FINAL TECHNICAL MEMORANDUM

TO: Dan Heilig, Wyoming Outdoor Council and
Jill Morrison, Powder River Basin Resource Council
FROM: Jean Marie Boyer, PhD, PE, Hydros Consulting Inc.
SUBJECT: Review of ERM Water-Quality Modeling Study of Boysen Reservoir
DATE: July 1, 2019

Figure 23. ERM Results for the Compliance Analysis for Dissolved Aluminum (Red Line and Two Text Boxes Added)

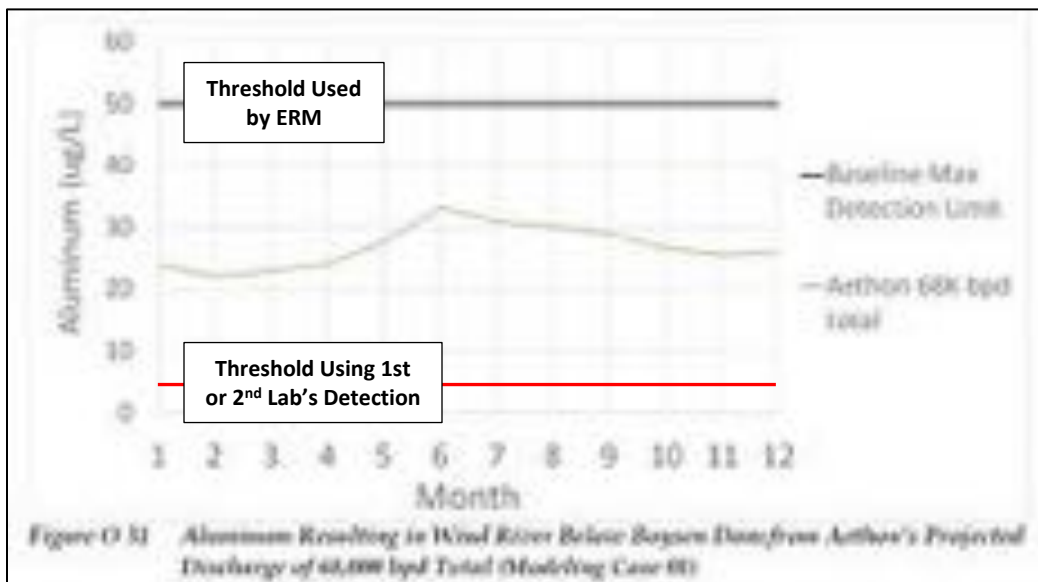
After lumping the model results and applying the adjustment factor (described above), the monthly model results are in the range of ~22-33 ug/L (Figure 23). This would show a problem if one compares these values to the 3-4 ug/L detection limits. ERM chose to set an alternative threshold of 50 ug/L and using that threshold, the project would not result in degradation.

The source of the 50 ug/L threshold appears to be the required detection limit for dissolved aluminum at the end of the pipe (WDEQ, 2019a). This 50 ug/L detection limit does not apply to the Class I segment of the Wind River (since it is not effluent) and use of this value by ERM for compliance is wrong.
